**MUNICIPAL PLANNING COMMISSION AGENDA  
SUMMER VILLAGE OF JARVIS BAY  
SUMMER VILLAGES ADMINISTRATION OFFICE  
FEBRUARY 28, 2023 @ 9:00 A.M.**

**165 Jarvis Bay Drive (Lot 1&2, Block 1, Plan 7278AA)**

### **Development Permit Application**

1 SITE PLAN  
A0.1 SCALE: 1:200

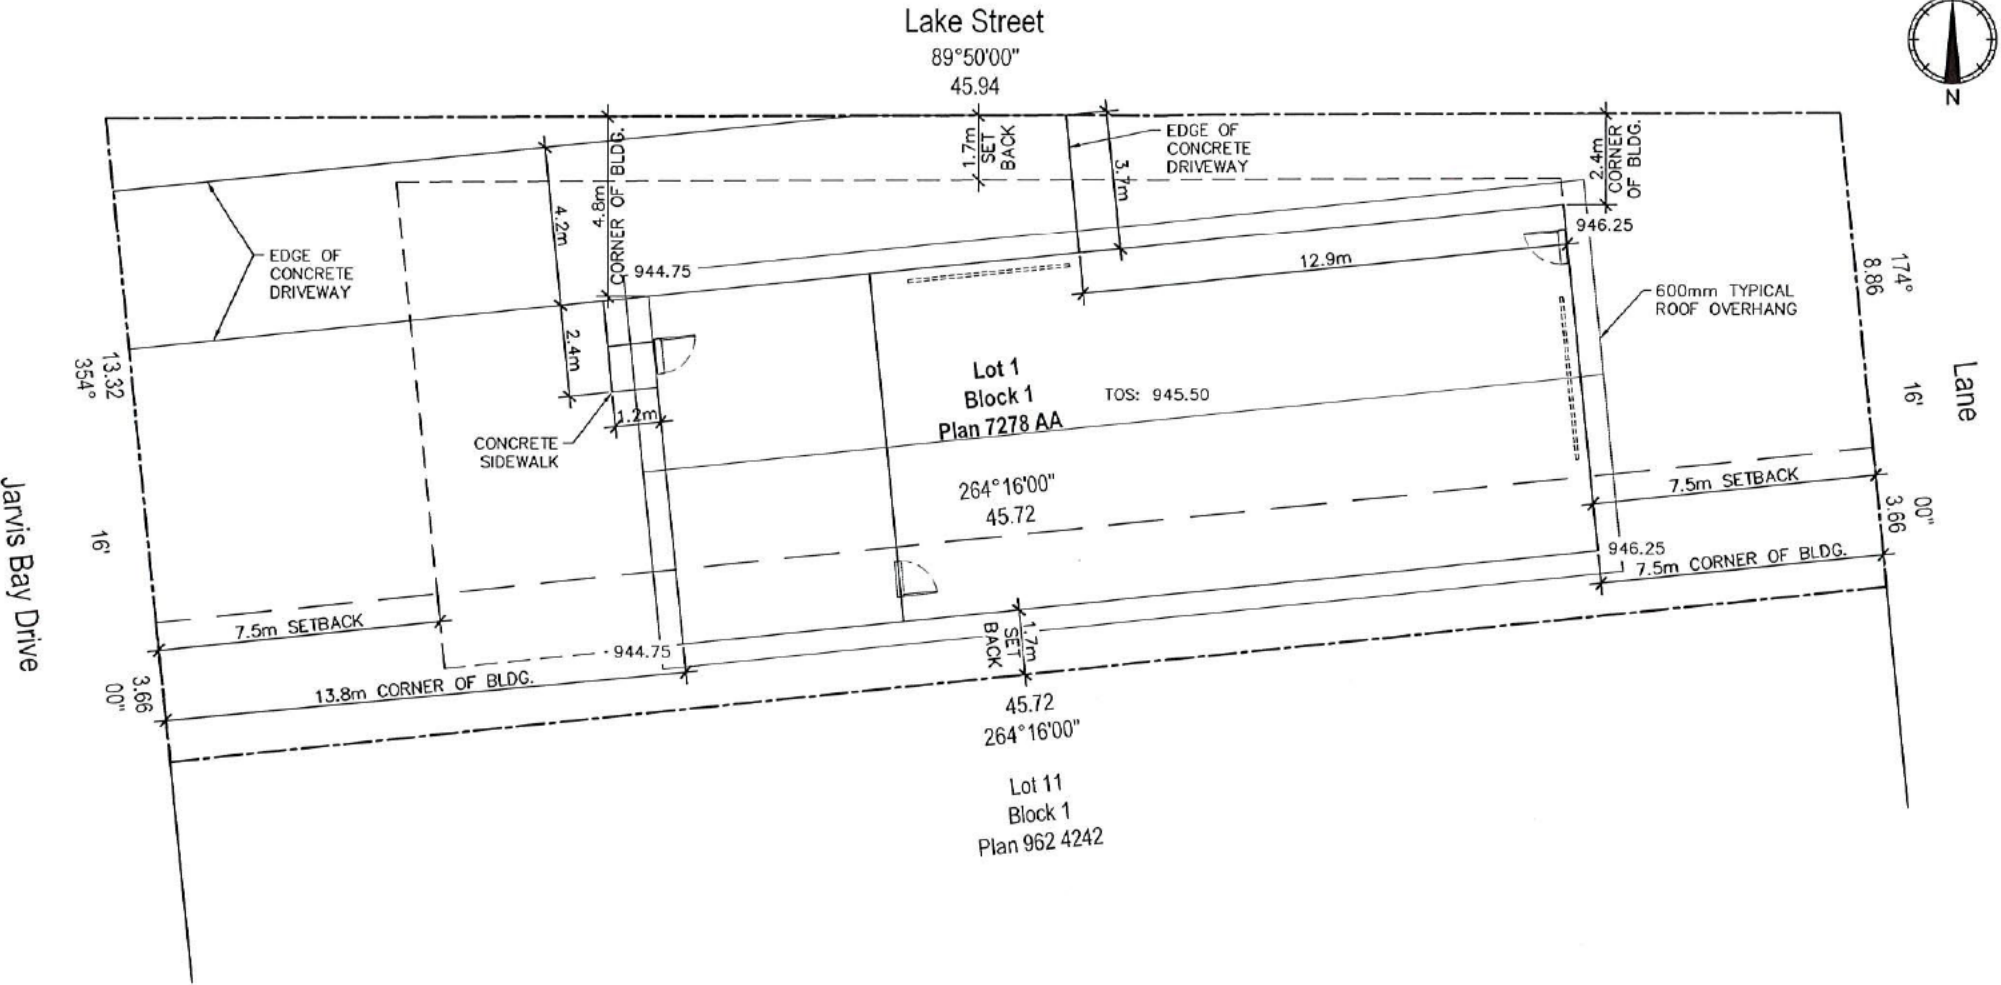
- The design, character and appearance of any building to be erected must be acceptable to the Development Authority having due regard to the character of existing development in the district. In administrations opinion a variance is required.
- Driveways on corner parcels shall be setback from the street intersection not less than 6m (19.69ft.). The proposed driveway setback is 1.7m (5.57ft.). Variance of 4.3m (11.12ft.) is required.

- Replanting of trees/shrubs and existing trees to remain according to landscaping plan.
- The number of driveways shall be limited to one and this shall be off of the West side of Jarvis Bay Drive. The existing driveway off of the North side of the property shall be removed.

1 FRONT ELEVATION  
A3.0 SCALE: 1/8" = 1'-0"

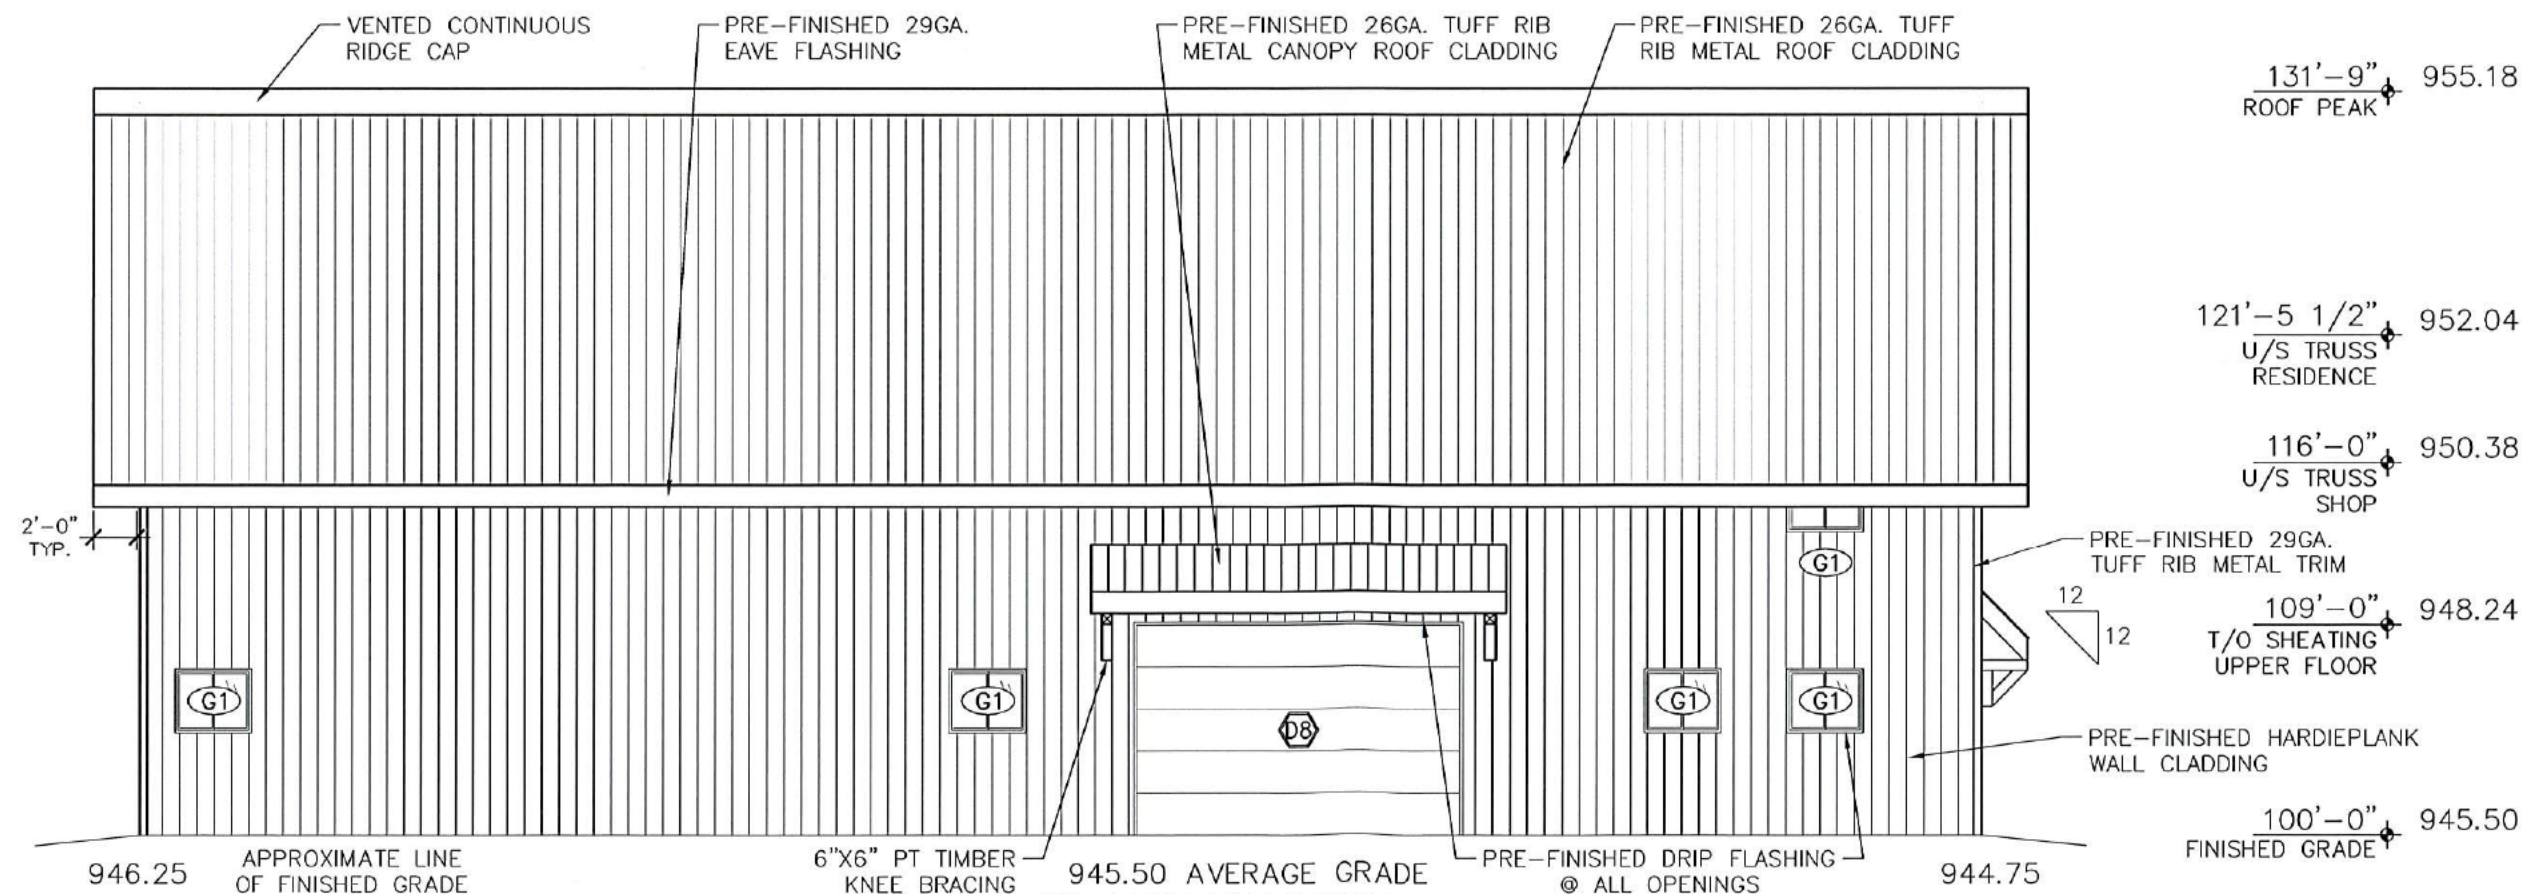
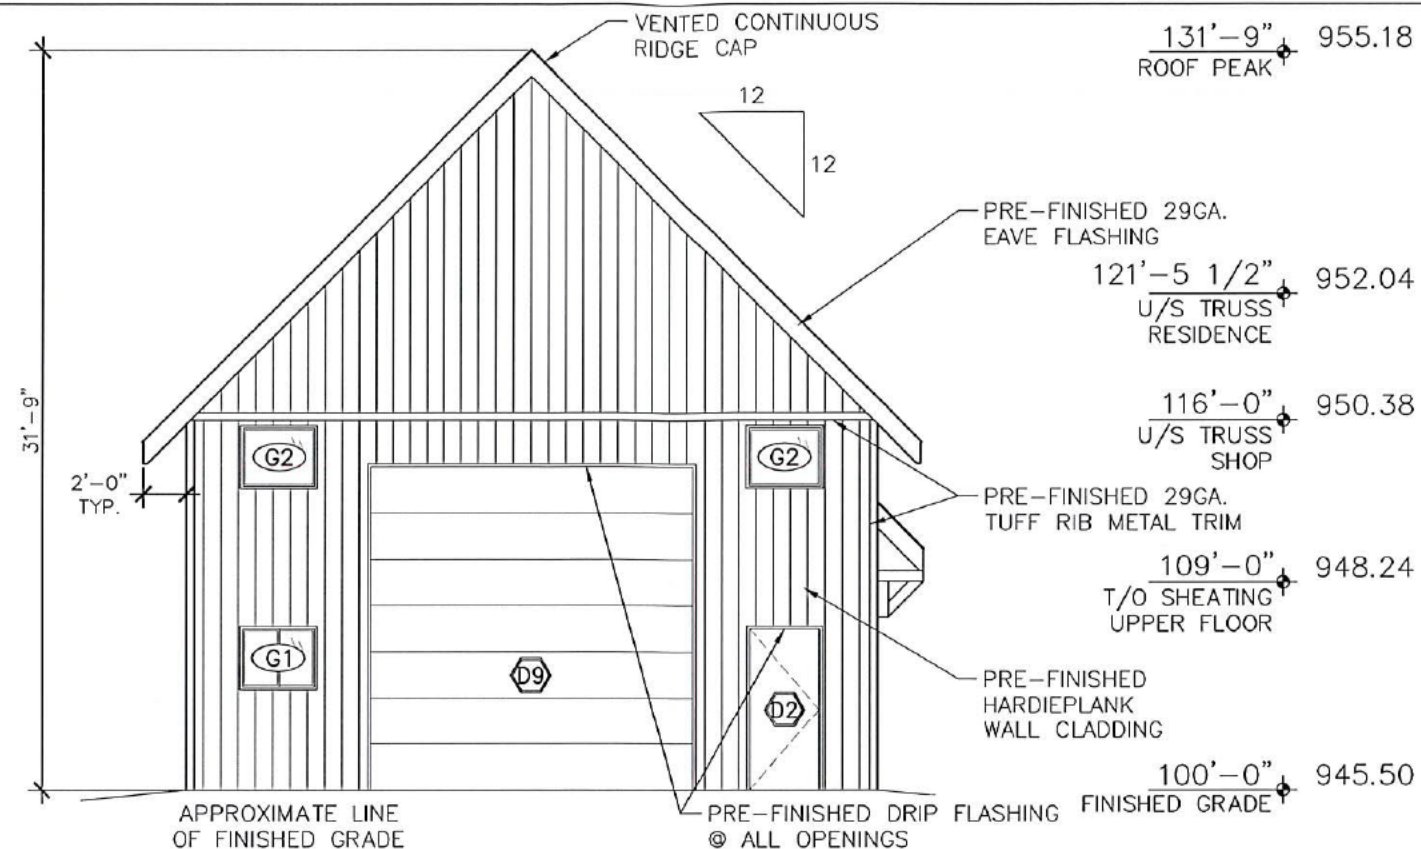
It is administrations recommendation to deny the dwelling with the variances requested, while the applicant has made amendments to the application to change roof pitch, garage door sizes, changes to the siding materials and addition of outside canopies off the building, in our opinion the proposed structure does not align with the character of the existing development in the village. Where a structure is designed with the shop being more than twice the size of the living space, the principal use of the structure is not low density residential, which is the purpose of the R-A District. Adjacent landowners have been notified of the proposed variance requests and opposed response has been received.
